NUMBER: 02-006-16

GROUP: Front Suspension

SUBJECT:

Toe Adjustment - Recirculating Ball Steering System

Fig. 1 Adjuster

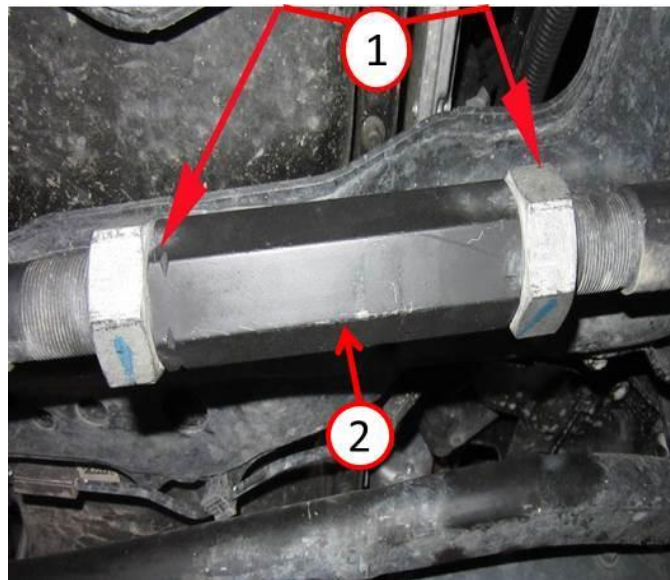
The vehicles identified above have a drag link with an adjustment sleeve and jam nuts (Fig. 1), which differs from the previous clamp and bolt style.

NOTE: When tightening the drag link jam nuts ([Fig. 1](#)), the adjuster sleeve must always be held secure with a wrench/tool.
